**DEPARTMENT OF PLANNING AND COMMUNITY DEVELOPMENT**

CASE NOS.: 11-SPR-006 & 11-OTP-012

LOCATION: 5446 Lewis Road (A.P.N. 2055-013-070)

REQUEST: Request for approval of a Site Plan/Architectural Review to construct a 4,195 square foot, single-story, single-family residence with an 893 square foot attached garage, and a swimming pool; and Oak Tree Permit to encroach within the protected zone of one oak tree for the proposed construction.

Sheet Content:  
 GRADING PLAN

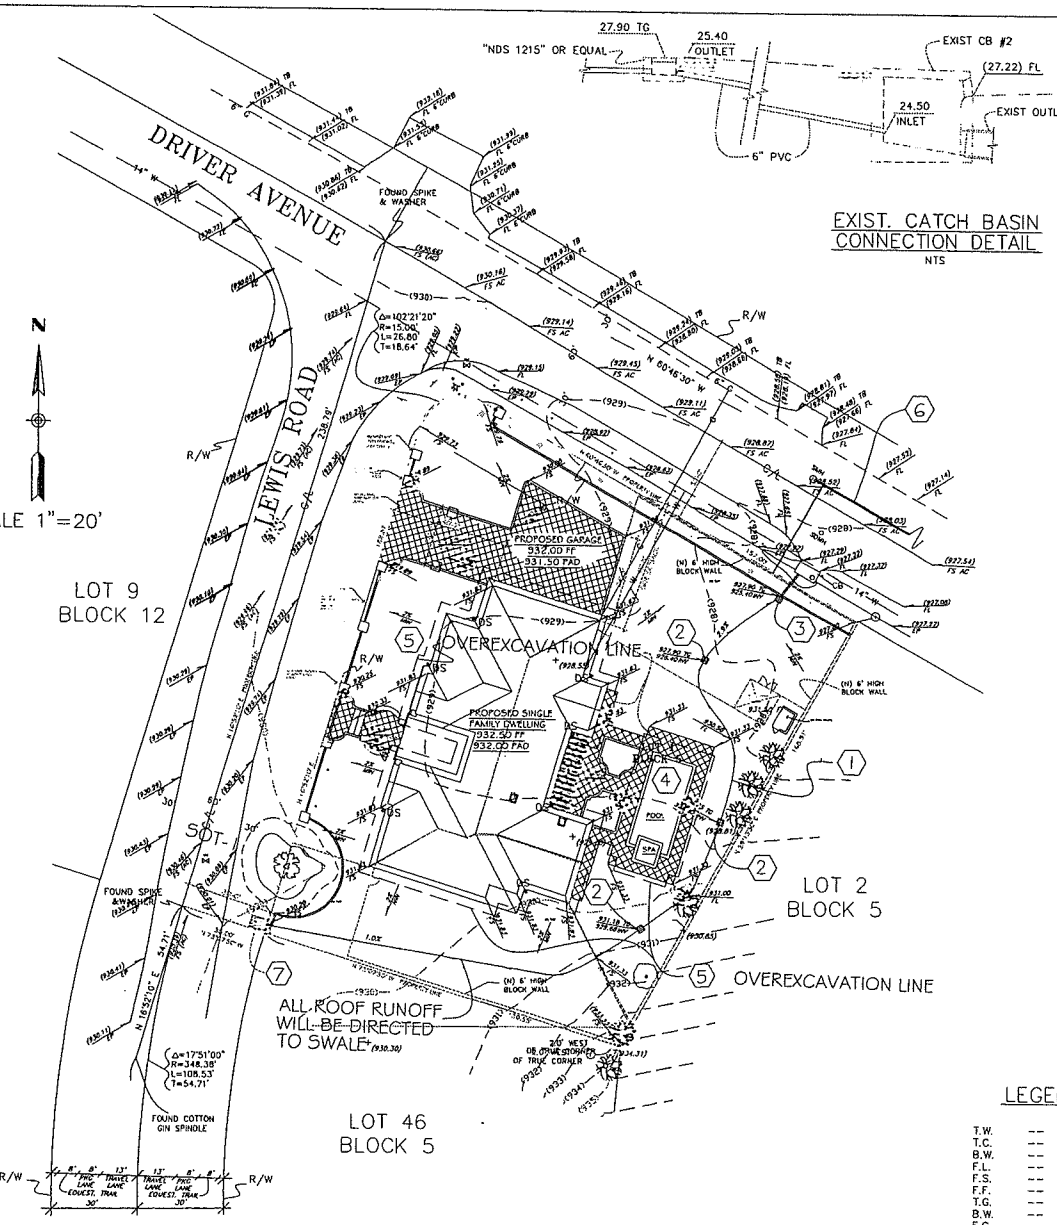
31. The grading plan shall include a survey 25 feet outside the project boundaries.
  32. The grading plan shall show street cross sections for Lewis Road and Driver Avenue per Old Agoura Standards. Cross-section for Lewis Road shall include a 30-foot half street right-of-way, a 14-foot travel lane, an 8-foot wide unpaved parking lane, and an 8-foot equestrian trail and fence. These items must be shown on the plans.

44. The applicant shall submit a hydrology study and drainage analysis, prepared and signed by a Civil Engineer registered in the State of California, in accordance with the Los Angeles County Hydrology Manual. Additional drainage facilities or portions of the site/grading plan may need to be altered as a result of the findings of this study. Among other things, study shall include verification that proposed flow to public roadways will not negatively impact flow to traffic.
45. The applicant shall relocate “reno mat” (Construction Note #7 on Sheet C-2.0) to location approved by the City Engineer,

Sheet Contents:  
 PLANTING PLAN

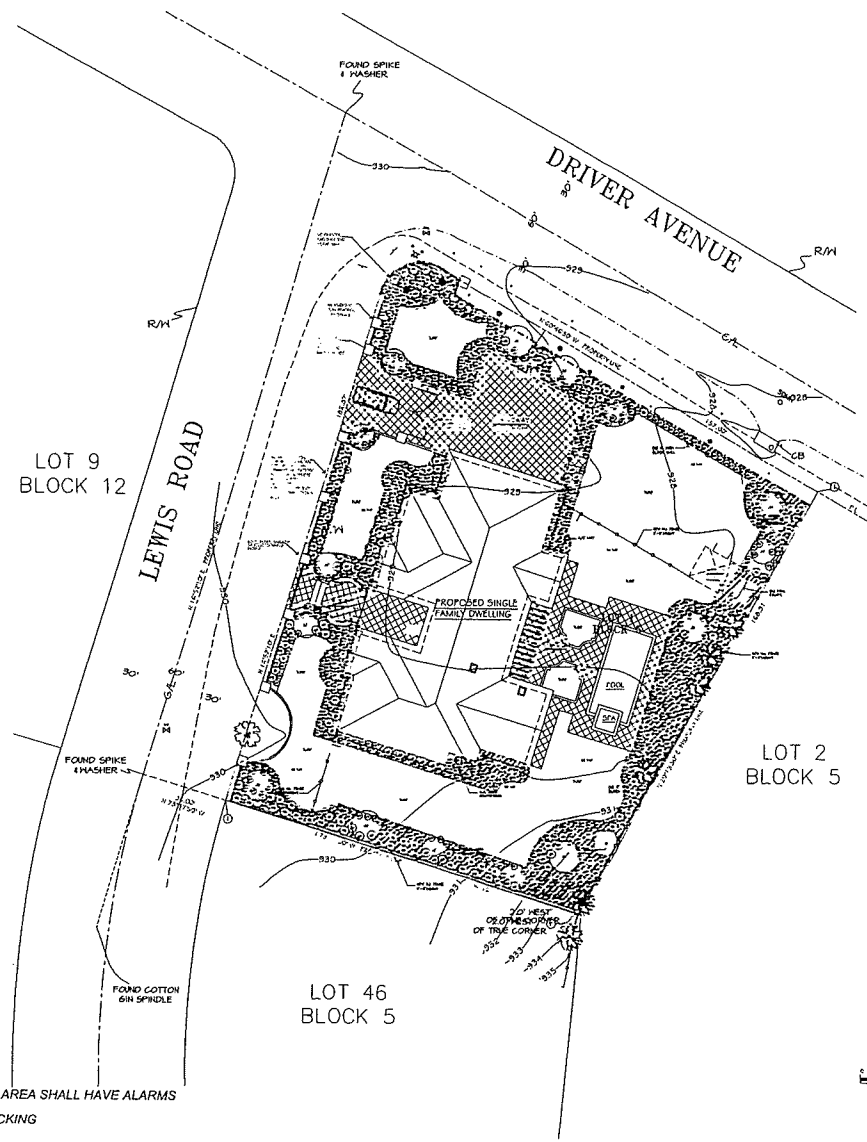
53. The landscape plan shall be revised to indicate the exact tag number, trunk location, dripline, and protected zone of Oak Tree SOT-1 as shown on the oak tree location map included in the Oak Tree Report prepared by Richard Campbell dated July 22, 2011.
54. The landscape plan shall be revised to indicate the correct configuration of the proposed stucco / wrought iron fence along Lewis Road.
55. The City shall not grant final approval to the grading plan until such time as the City Oak Tree Consultant has reviewed the plan and determined that its implementation will not adversely affect the oak tree.

67. The jacaranda tree (*Jacaranda mimosifolia*) proposed on the landscape plan shall be located a minimum of thirty-five feet (35') from the trunk of Oak Tree SOT-1 to prevent conflict with the canopy of the oak tree.
